Planning Commission
Item PH-2

Culver Studios

COMMENTS IN REGARD TO CULVER STUDIOS COMPREHENSIVE PLAN AMENDMENT NO. 6

For the foregoing reasons, it is respectfully submitted that the Modified Comprehensive Plan Amendment # 6 should be rejected, or referred back to the proponent and staff for further analysis, and to allow more informed public comment.

1/5 mile backup on Irving Place during morning rush hour¹⁴

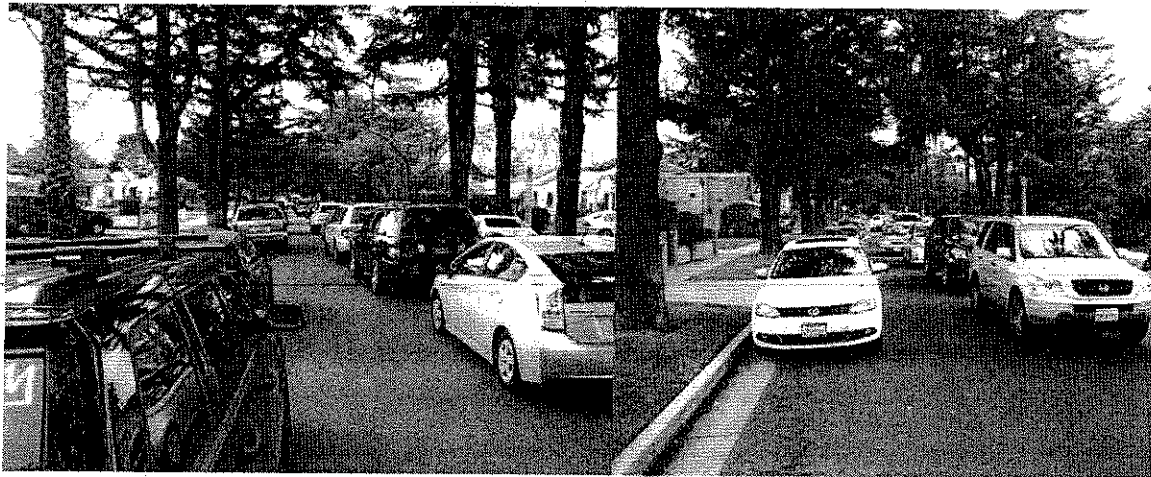
7. Not only has Irving Place – a designated "local street" – already been transformed into a thoroughfare, it poses a real safety hazard at certain times of the day. The pictures below show how Irving Place backs up during drop-off and pickup times at Linwood E. Howe School.¹³ Because it is a one-way street, there is no other exit for homes on the street and no way for emergency vehicles to reach local residences.
